ACCESSION NBR: 8702180096 DOC. DATE: 87/02/09 NOTARIZED: NO DOCKET #
 FACIL: 50-335 St. Lucie Plant, Unit 1, Florida Power & Light Co. 05000335
 50-389 St. Lucie Plant, Unit 2, Florida Power & Light Co. 05000389
 AUTH. NAME AUTHOR AFFILIATION
 WOODY, C. O. Florida Power & Light Co.
 RECIPIENT AFFILIATION
 Document Control Branch (Document Control Desk)

SUBJECT: Forwards addl info for 860702 application for amend to
 License NPF-16 re spent fuel storage, per 861210 request.
 Shipping cask Models NAC-1 & NLI-1/2 only casks that meet 25
 ton Tech Spec limit for Unit 1 cask crane.

L-87-48

REQUEST FOR ADDITIONAL INFORMATION
FLORIDA POWER & LIGHT COMPANY
ST. LUCIE UNITS 1 AND 2
SPENT FUEL TRANSFER BETWEEN UNITS
PLANT, ELECTRICAL, INSTRUMENTATION AND CONTROL SYSTEMS BRANCH

Figure 1-1
Spent Fuel Storage
St. Lucie Unit 1

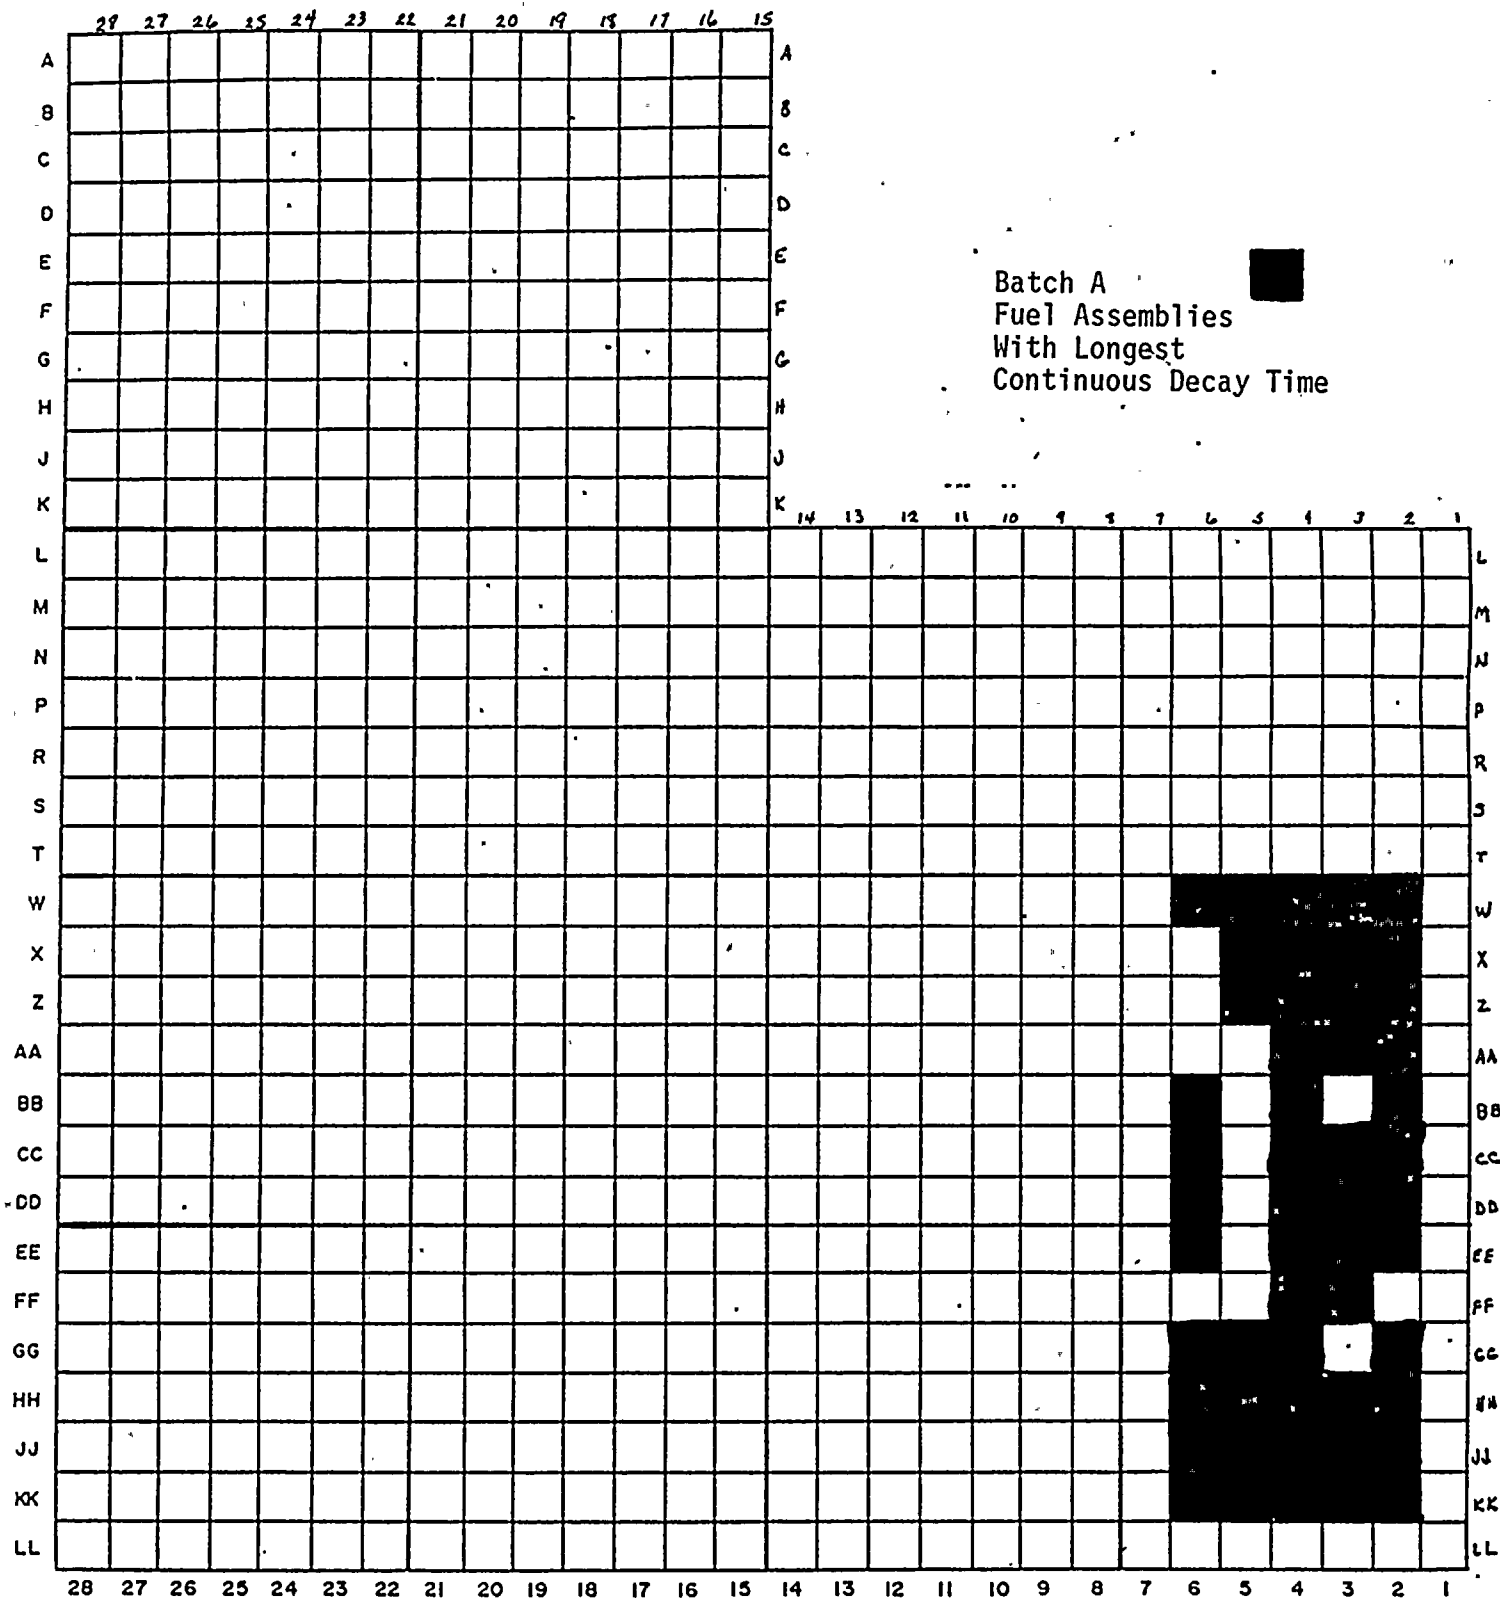
1. Provide further details regarding the Unit 1 SFAs to be stored in the Unit 2 SFP. The details should include number, type and age of existing SFAs to be transferred to Unit 2 and the SFA locations in the Unit 2 storage racks to be utilized. Also provide any necessary drawings to clarify your response.

Although the proposed amendment would not limit the number of SFAs that could be transferred to the Unit 2 SFP, it is expected that only 15 to 25 SFAs would be subject to transfer, should this option become necessary. Figure 1-1 shows the Unit 1 spent fuel pool with the Batch A assemblies indicated.

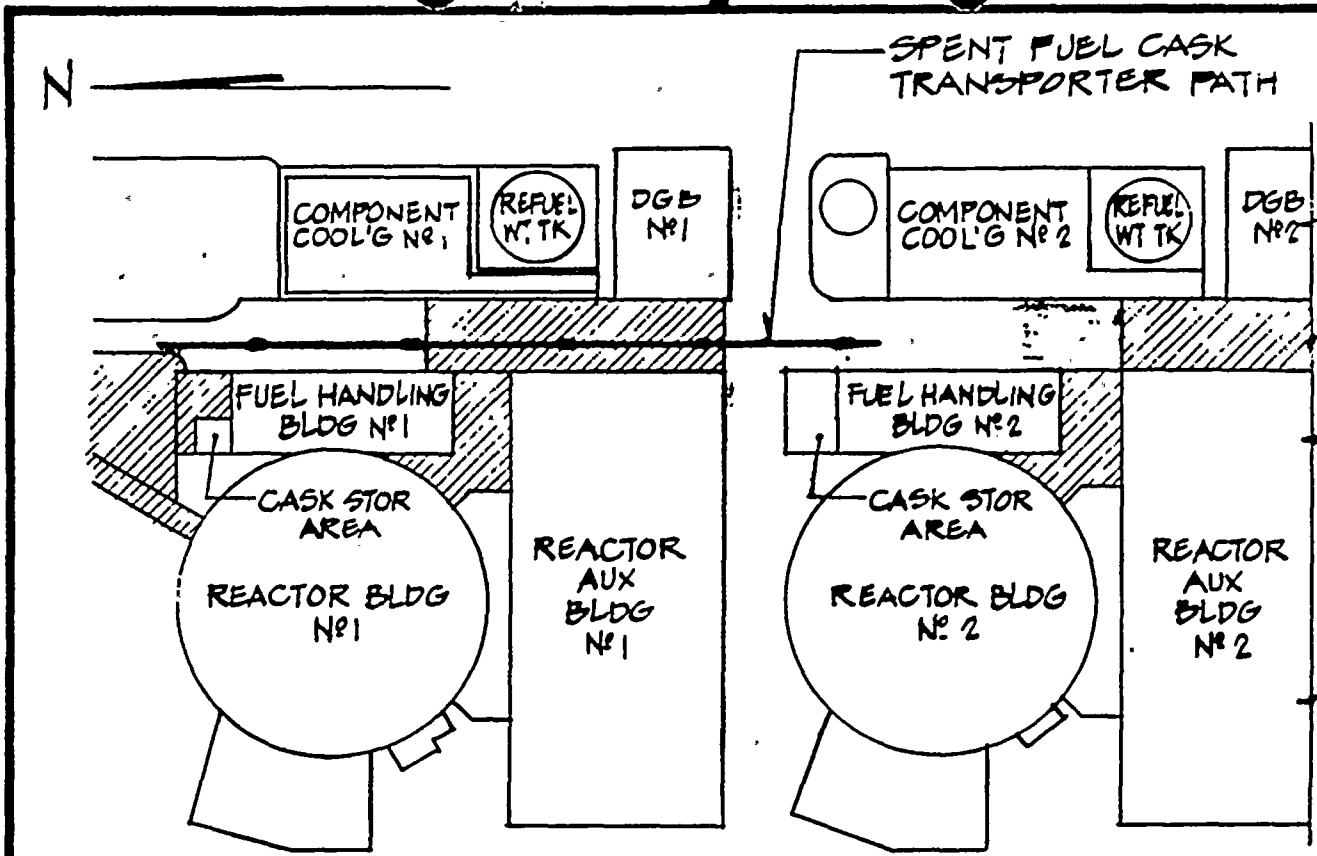
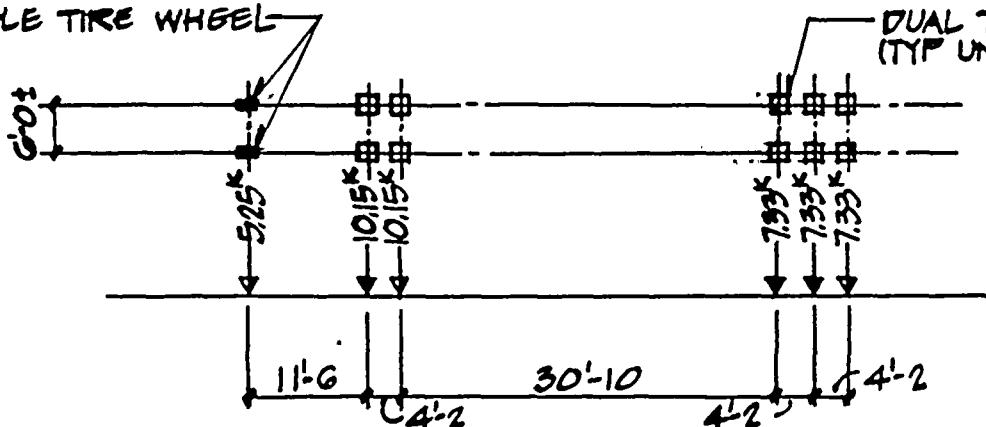
3. Provide a summary of the evaluation performed concerning the shipping cask load path between the units. This summary should include a discussion of the means utilized to confirm that safety related equipment including piping, components, and electric conduits that are located near the load path and those that are buried under the load path will not be adversely affected with regard to their capability to perform their intended safety functions during normal spent fuel transfer from Unit 1 to Unit 2 and in the event of an accident such as cask drop. Also, provide any necessary drawings to clarify your response.

The evaluation considered a spent fuel trans-shipment path starting at the Unit 1 cask loading area and traveling to the Unit 2 cask loading area as indicated in Figure 3-1. This path, in its entirety, coincides with a portion of the intermodal cask transporter path previously evaluated for effects upon underground structures and utilities. The spent fuel trans-shipment path road surface is paved with Portland cement concrete or asphaltic concrete.

The fuel elements to be transported will utilize a one element shipping cask having a maximum weight of 25 tons when loaded with the spent fuel assembly. Two transport vehicles were considered in the evaluation. Wheel loads for the two vehicles are shown in Figures 3-1 and 3-2. The reactions of the two transport vehicles were compared to the maximum reactions of the intermodal cask transporter that was previously evaluated. Since the reactions of the intermodal cask transporter are greater than the reaction for either of the two transport vehicles, the intermodal cask transporter evaluation is considered to be an enveloping evaluation.

The effect of the intermodal cask transporter wheel loads (and thus the spent fuel transporter wheel loads) on the roadway, missile protection slabs and underground facilities (i.e., pipes, electrical conduit, manholes and catch basins) has been analyzed. The punching shear of the concrete roadway is acceptable for surface areas of both single and dual tire wheels. Each surface area was also evaluated for maximum soil bearing capacity and found to be acceptable. The maximum stresses and deflections of the missile protection slabs, underground pipes and conduit are within the allowable range. The ultimate strength design of the manholes and catch basins using the appropriate load criteria was reviewed and found to be acceptable.
